## Request for Comments

Case Name: Berkeley Center Subdivision

Case Number: PLT2023-00056

## Development Review Team Comments

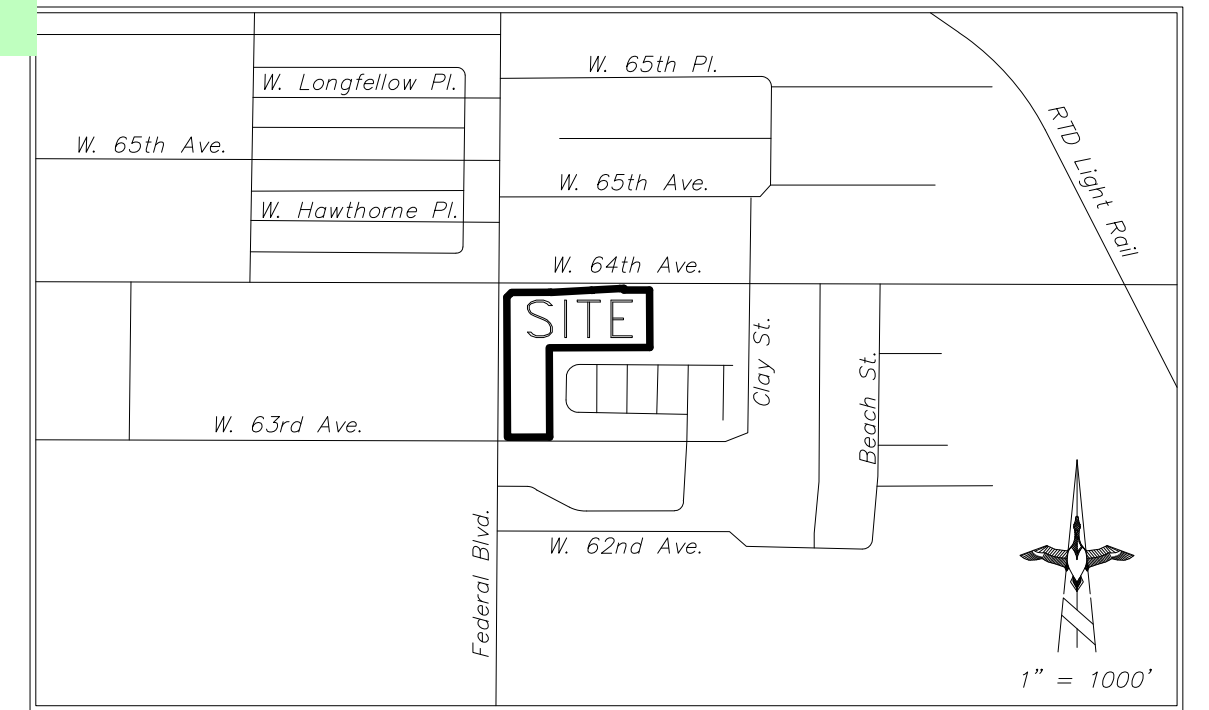
ROW9: Revise all dates to current year.

THE UNDERSIGNED CERTIFIES TO AND FOR THE BENEFIT OF THE CITY COUNCIL OF DENVER CITY, COLORADO, THAT AS OF THE DATE SET FORTH BELOW WE, QUIKTRIP CORPORATION, BEING THE OWNER(S) OF THE PROPERTY SHOWN HEREON, DO HEREBY DEDICATE TO DENVER CITY, AND APPROPRIATE UTILITY COMPANIES AND EMERGENCY ASSISTANCE ENTITIES, THE EASEMENTS AS SHOWN HEREON FOR THE PURPOSES STATED IN COMPLIANCE WITH THE CITY OF DENVER SUBDIVISION REGULATIONS AND THE LANDOWNERS SHALL BEAR ALL EXPENSE INVOLVED IN PLANNING, DESIGN, AND CONSTRUCTION OF ALL PUBLIC IMPROVEMENTS EXCEPT TO THE EXTENT EXPRESSLY STATED IN ANY CITY-APPROVED AND RECORDED SUBDIVISION IMPROVEMENT AGREEMENT. DEDICATION SHALL BE FINAL UPON ADOPTION BY THE CITY COUNCIL ACCEPTING THE PROPERTY DEDICATED BY THIS PLAT. EXCEPT AS OTHERWISE STATED ON THIS PLAT, THERE SHALL BE NO LIMITATION OR RESTRICTION UPON THE PURPOSE OR PUBLIC USE OF PROPERTY DEDICATED BY THIS PLAT.

**Response: Updated.**

Response: Revised year to 2024, as requested.

SHEET 1 OF 3

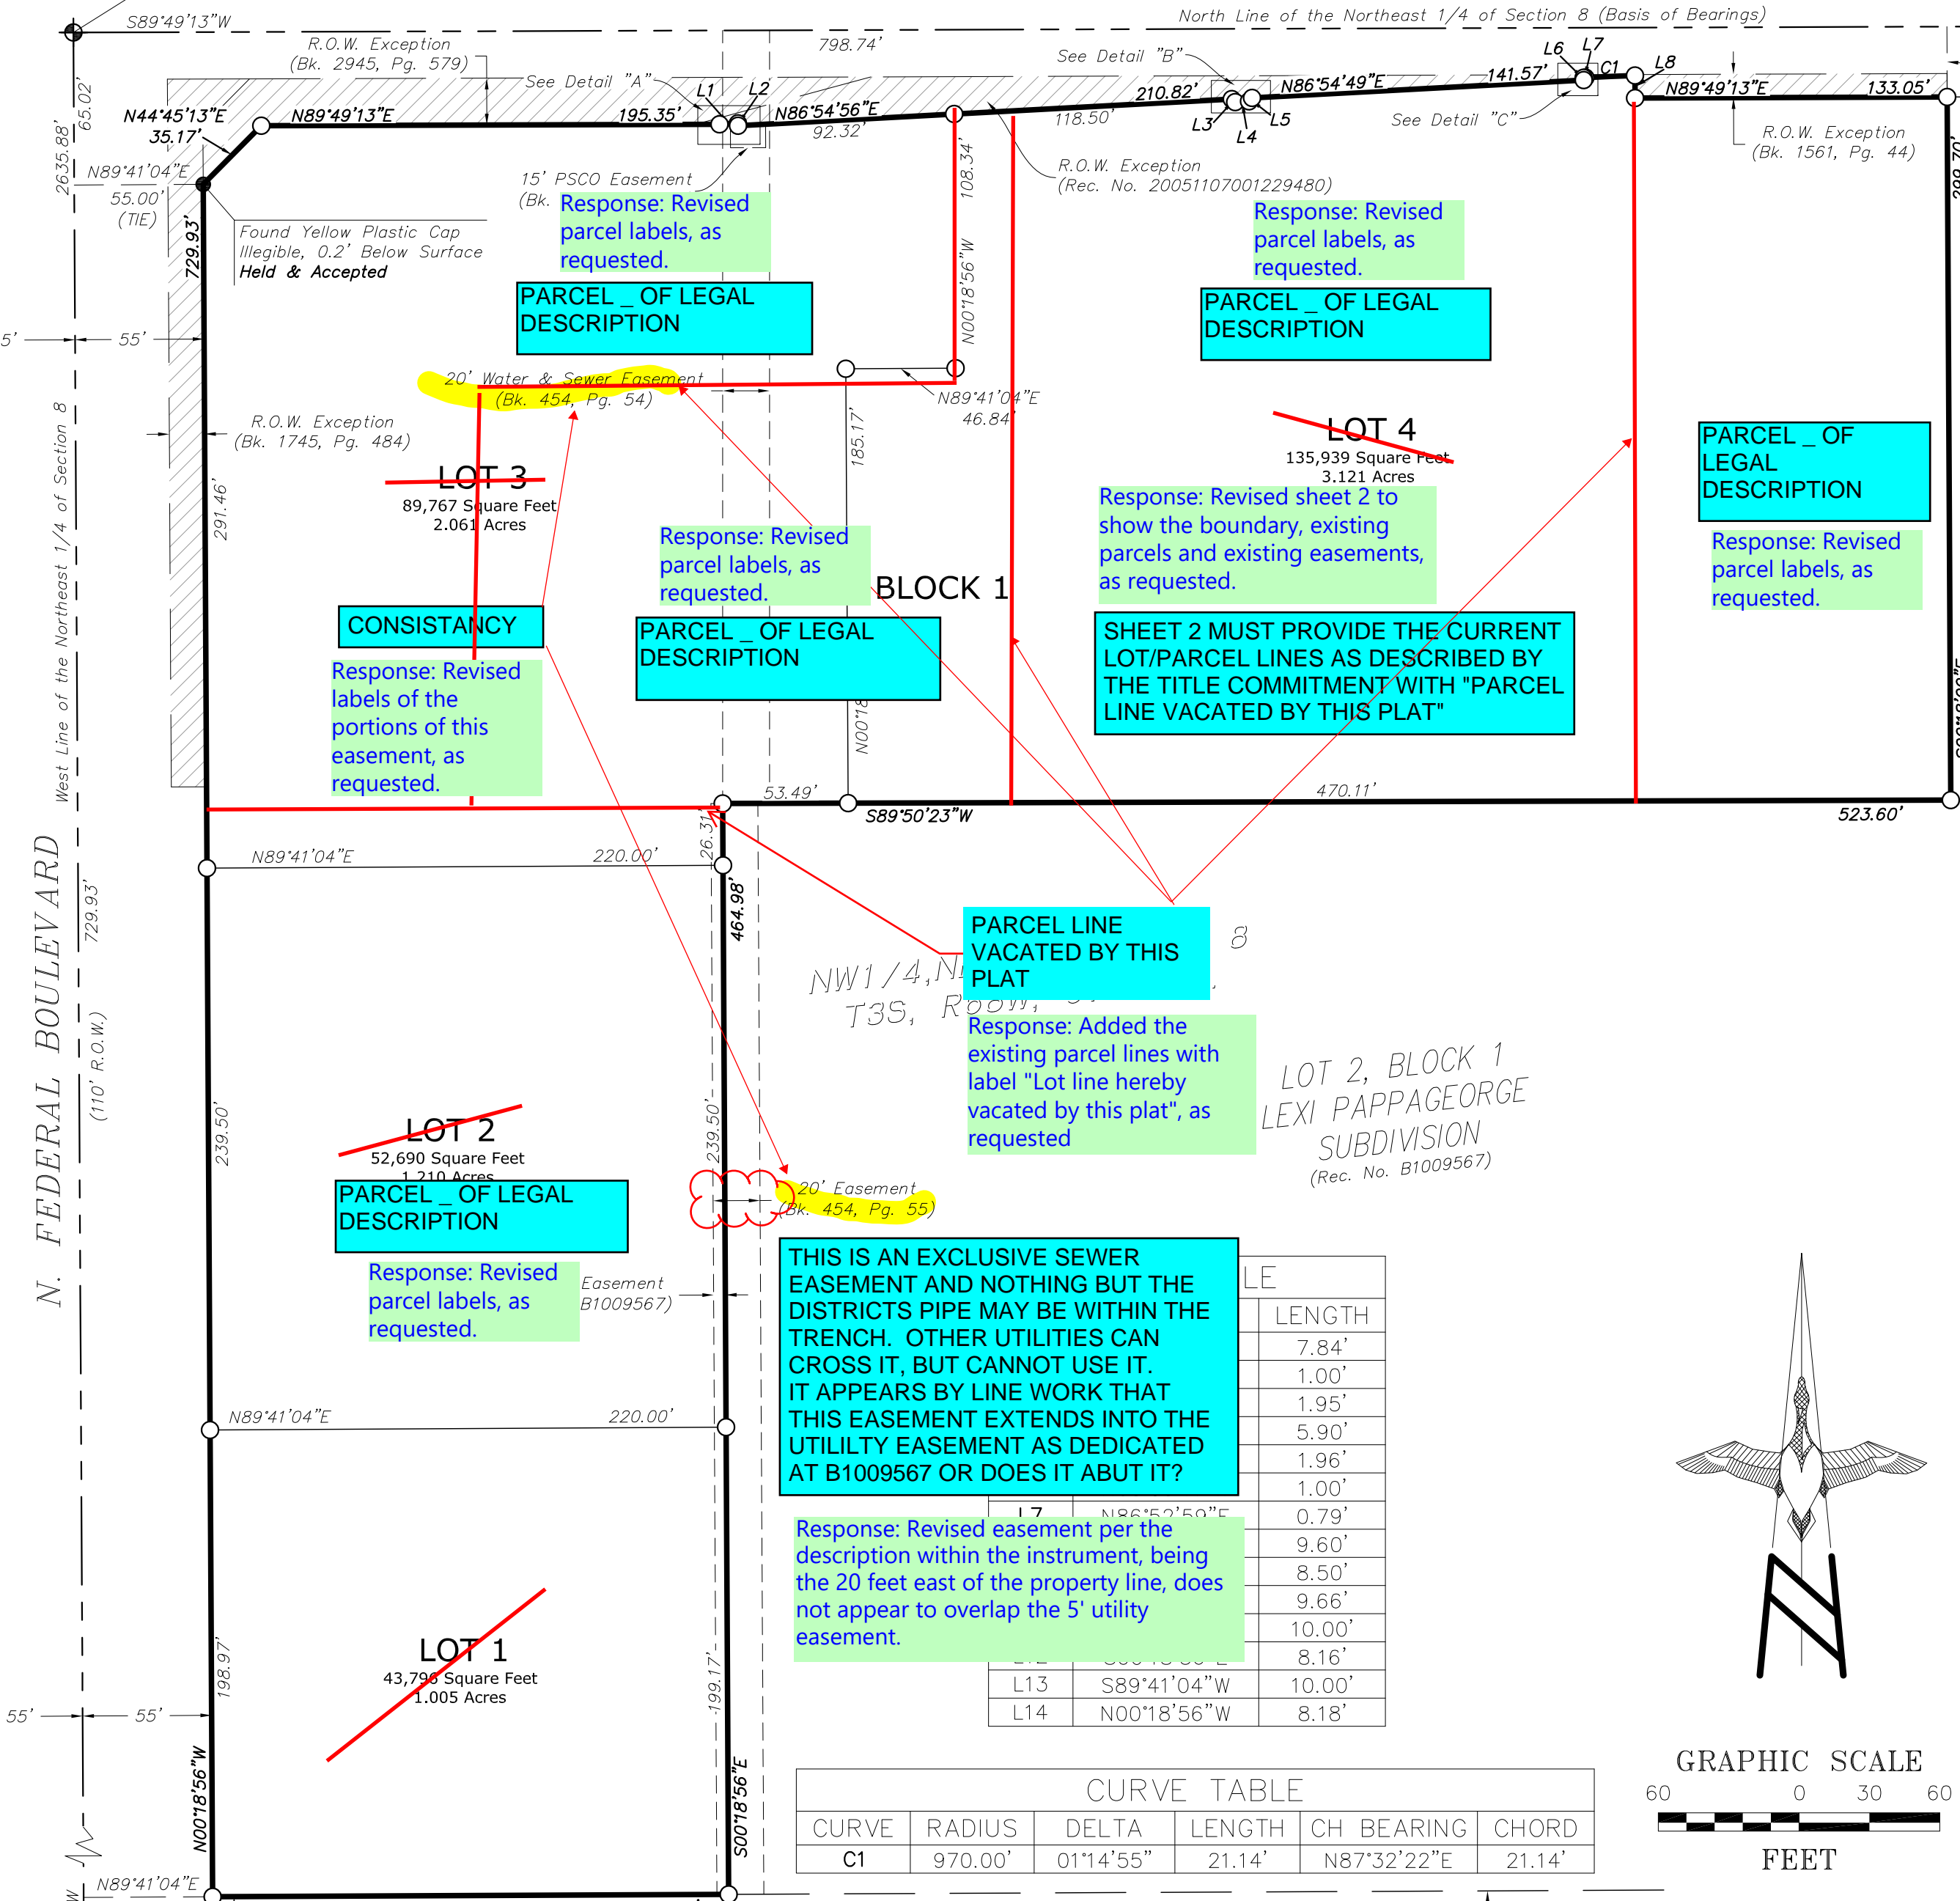
PROVIDE THE: PLANNING COMMISSION RECOMENDATION FOR APPROVAL BOARD OF COUNTY COMISSIONERS APPROVAL COUNTY ATTORNEY' APPROVED AS TO FORM CLERK AND RECORDER SIGNATURE BLOCKS

MUST PROVIDE A COPY OF A RECORDED STATEMENT OF AUTHORITY FOR JASON ACORD TO HAVE SIGNATORY ABILITY OR A COPY OF THE OPERATING AGREEMENT

A REPLAT OF LOT 1, BLOCK 1, ELLETT SUBDIVISION, LOT 1 BLOCK 1, LEXI PAPPAGEORGE  
 NORTHWEST 1/4 OF THE NORTHEAST 1/4 OF SECTION 8, LYING WITHIN THE NORTHEAST 1/4 SECTION 8,  
 TOWNSHIP 3 SOUTH, RANGE 68 WEST OF THE 6TH PRINCIPAL MERIDIAN, CITY OF DENVER, COUNTY OF ADAMS, STATE OF COLORADO

Response: Replaced all signature blocks with Adams County signature blocks per the checklist and guidelines, as requested.

Response: Not a survey related matter.

Response: This is the quarter section all of the parcels are within and needs to be part of the title. Added "All" before lying within... for clarity.

Response: Added the case no. to all sheets, as requested.

Response: Removed "City of Denver" from the subdivision title as requested.

SHEET 2 OF 3  
 W. 64th AVENUE  
 (R.O.W. Varies)

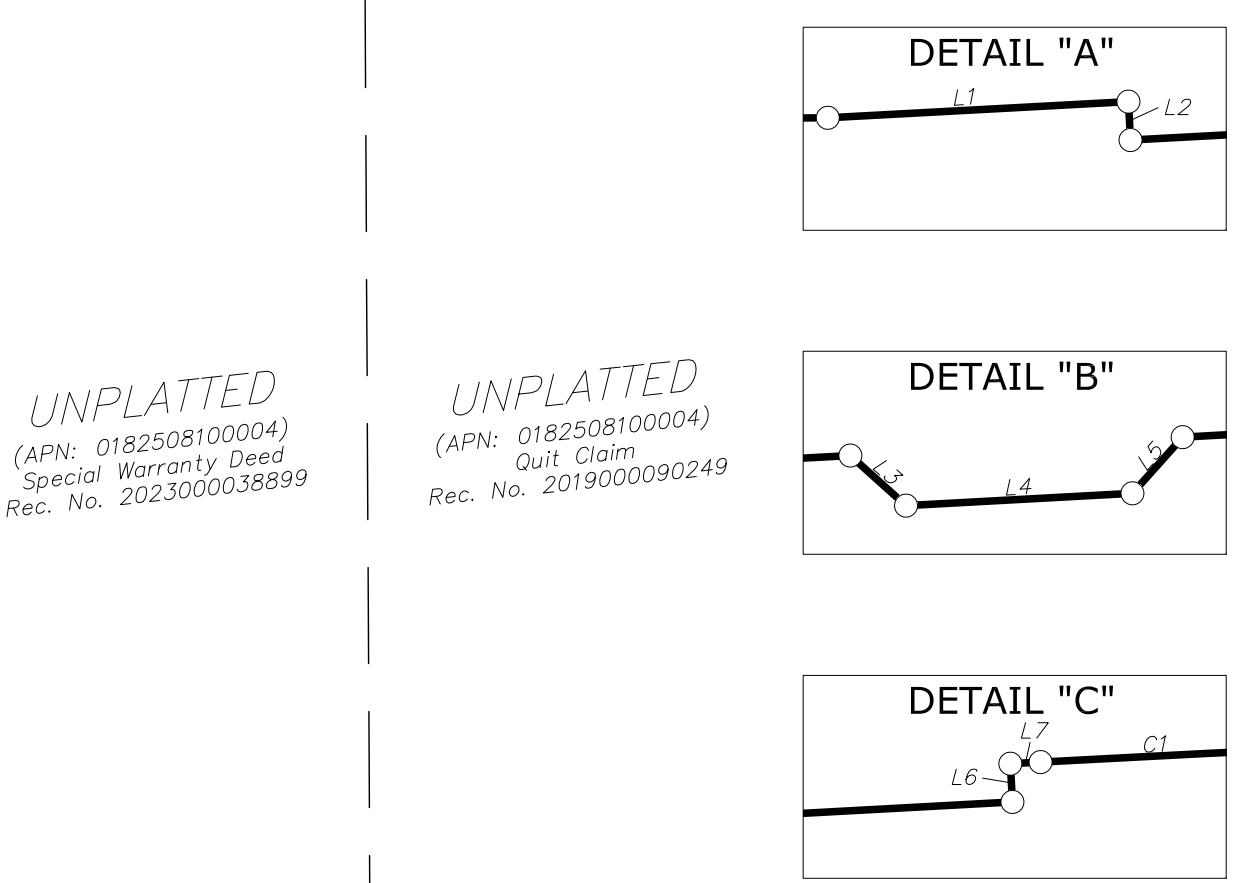
ROW13: Sheet 2 is the existing conditions and parcel lines. Do not provide where the new lots are to be located on this sheet. These parcel lines must be vacated. The parcels must be referenced as to the legal descriptions provided on sheet 1. You must state parcel lines being vacated by this plat.

SHEET 2 MUST PROVIDE THE CURRENT LOT/PARCEL LINES AS DESCRIBED BY THE TITLE COMMITMENT WITH "PARCEL LINE VACATED BY THIS PLAT"

**Response: Updated.**

Response: Added the existing parcel lines with label "Lot line hereby vacated by this plat", as requested

Response: Revised easement per the description within the instrument, being the 20 feet east of the property line, does not appear to overlap the 5' utility easement.

SHEET 3 OF 3

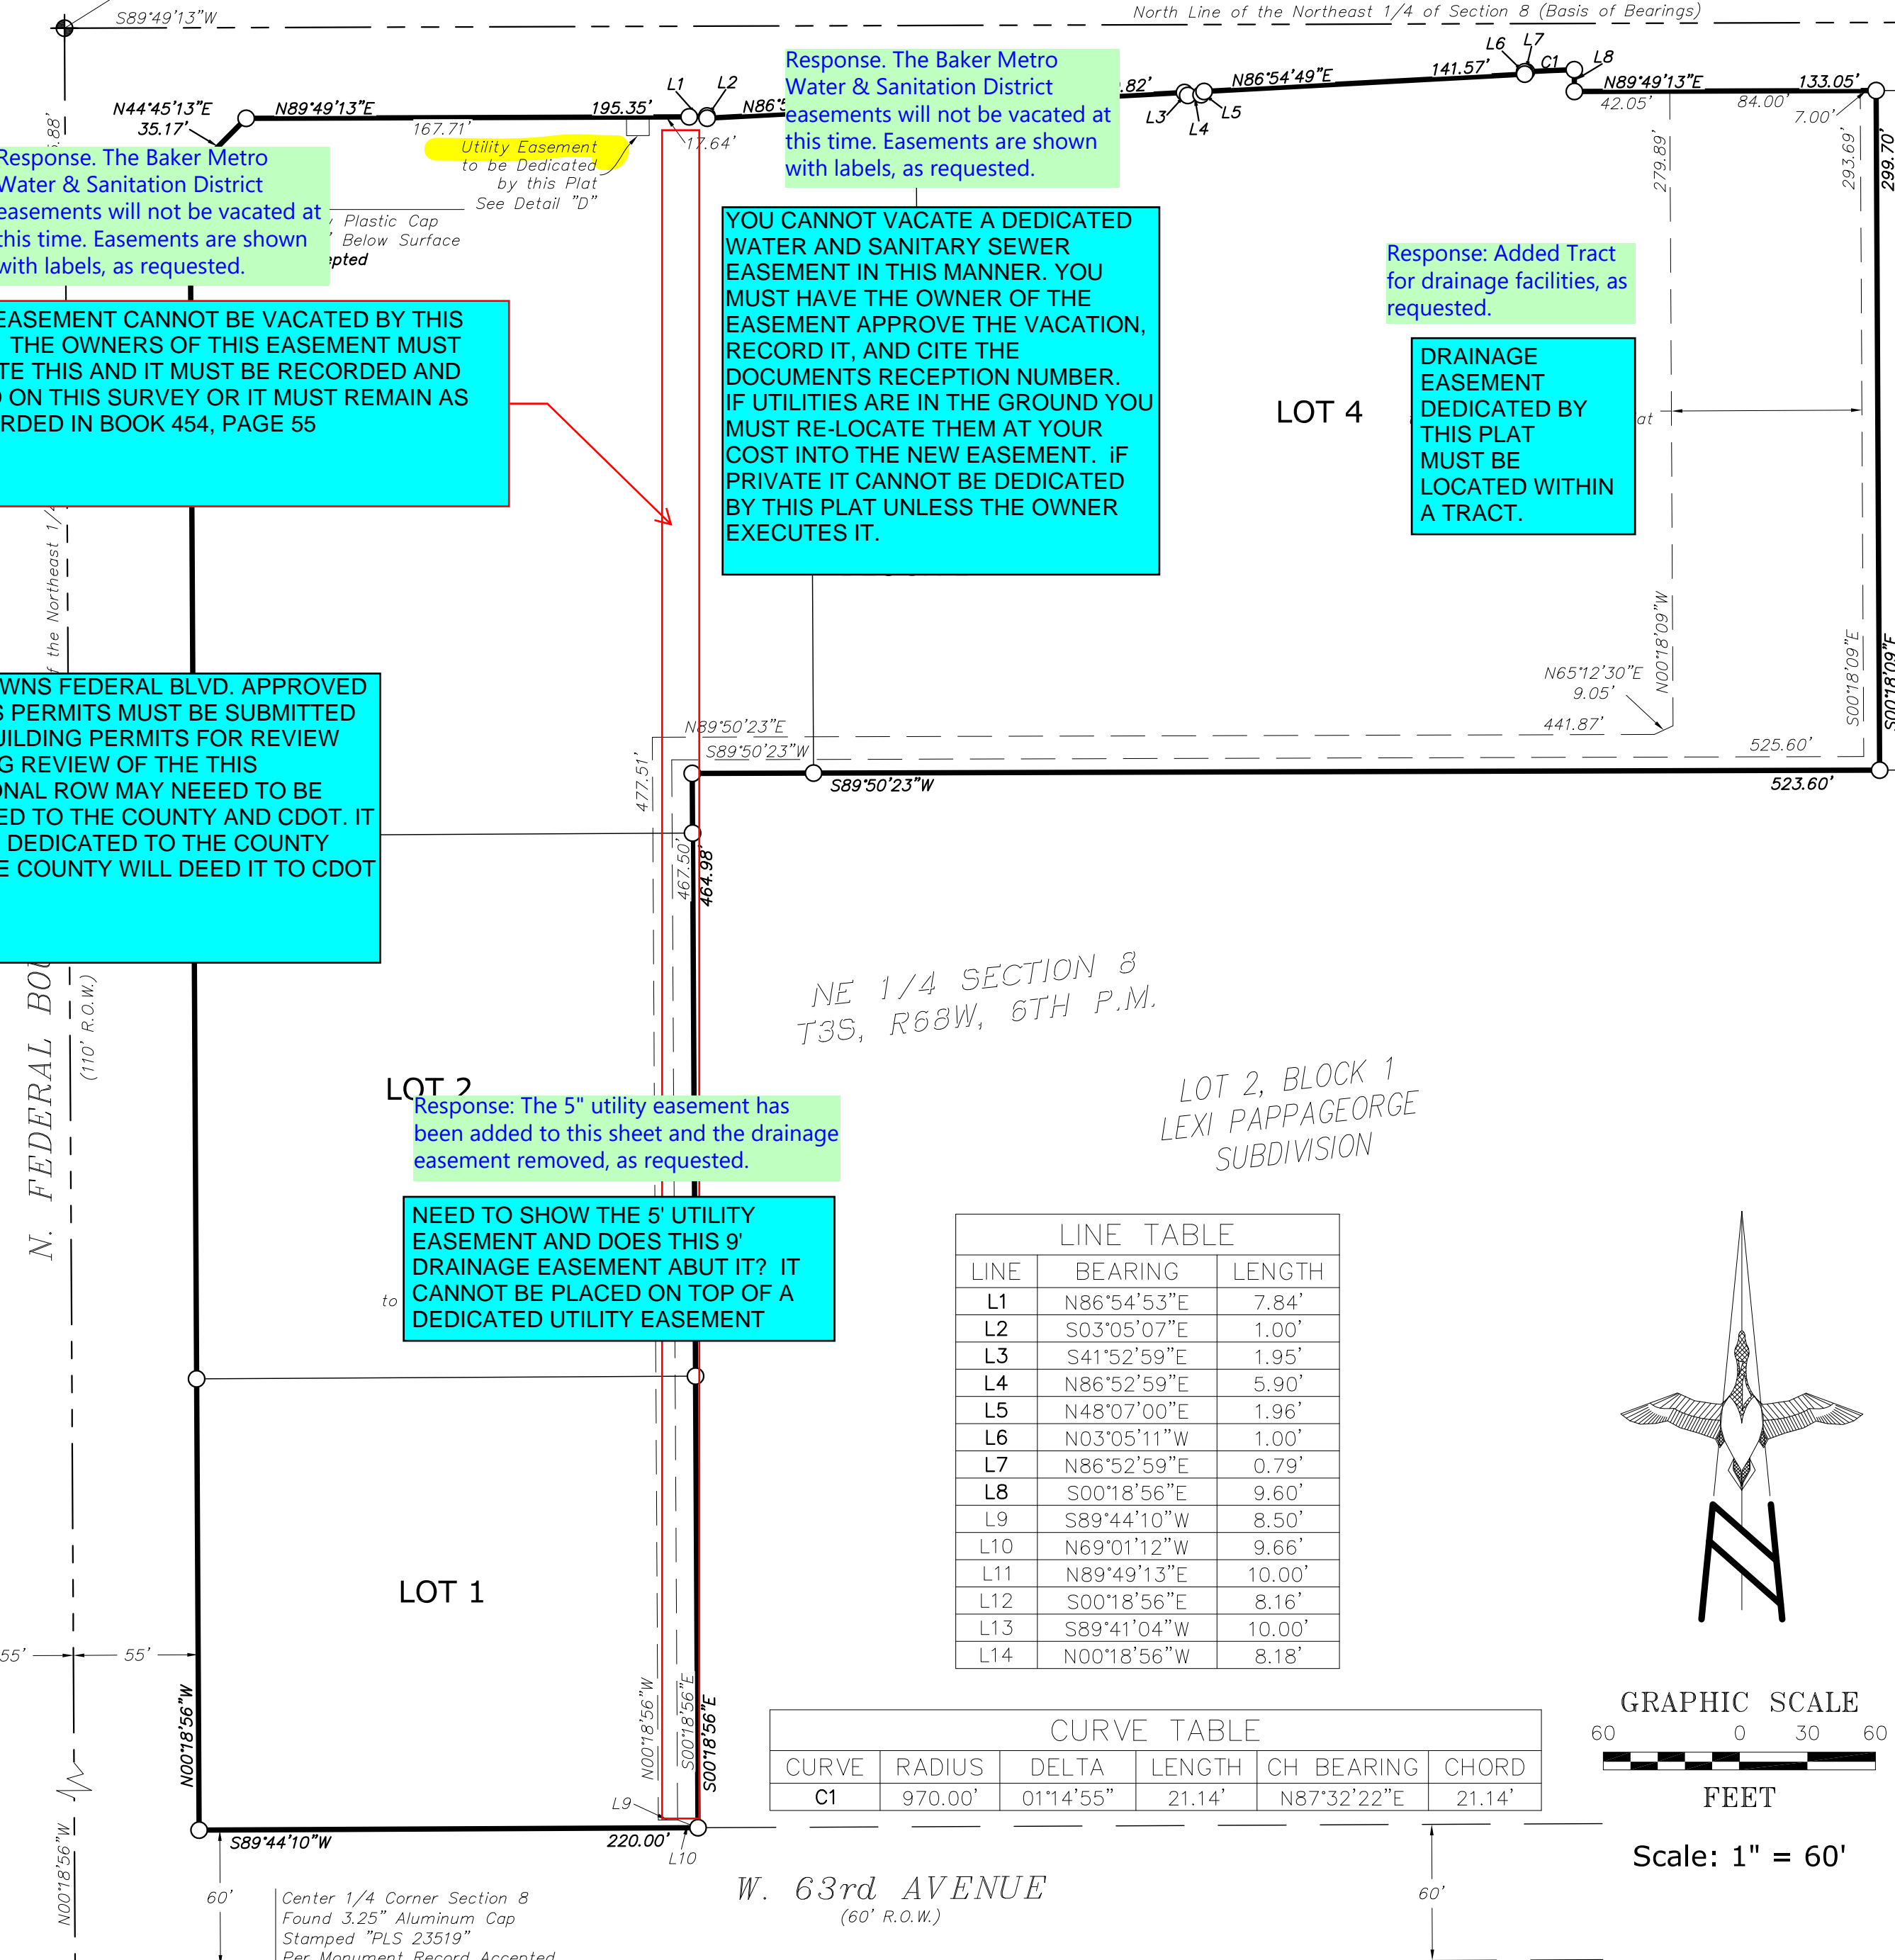
ROW15: The easements that appear to be missing cannot be vacated by this plat and must remain in place. If needing to vacate these easements, it will be an agreement between the property owner and the owner of the utility easement. Once the vacation has been completed and recorded, cite the vacation reception number. If utilities are installed it will be at the owners expense to move these utilities and provide a new easement. The easement/ROW document cited above is exclusively for sanitary sewer. It can be crossed, but nothing can share the trench. Does the 9' wide drainage easement being dedicated about the 5' wide utility easement as recorded at B1009567? The new one cannot lay on top of the existing. **Response: Easement to not be vacated. Drainage easement crosses utility easement.**

YOU CANNOT VACATE A DEDICATED WATER AND SANITARY SEWER EASEMENT IN THIS MANNER. YOU MUST HAVE THE OWNER OF THE EASEMENT APPROVE THE VACATION, RECORD IT, AND CITE THE DOCUMENTS RECEPTION NUMBER. IF UTILITIES ARE IN THE GROUND YOU MUST RE-LOCATE THEM AT YOUR COST INTO THE NEW EASEMENT. IF PRIVATE IT CANNOT BE DEDICATED BY THIS PLAT UNLESS THE OWNER EXECUTES IT.

DRAINAGE EASEMENT DEDICATED BY THIS PLAT MUST BE LOCATED WITHIN A TRACT.

THIS EASEMENT CANNOT BE VACATED BY THIS PLAT. THE OWNERS OF THIS EASEMENT MUST VACATE THIS AND IT MUST BE RECORDED AND CITED ON THIS SURVEY OR IT MUST REMAIN AS RECORDED IN BOOK 454, PAGE 55

NEED TO SHOW THE 5' UTILITY EASEMENT AND DOES THIS 9' DRAINAGE EASEMENT ABUT IT? IT CANNOT BE PLACED ON TOP OF A DEDICATED UTILITY EASEMENT

Response: Removed "City of Denver" from the subdivision title as requested.

Response: Added the case no. to all sheets, as requested.

Response. The Baker Metro Water & Sanitation District easements will not be vacated at this time. Easements are shown with labels, as requested.

Response: Added Tract for drainage facilities, as requested.

Response: The 5" utility easement has been added to this sheet and the drainage easement removed, as requested.
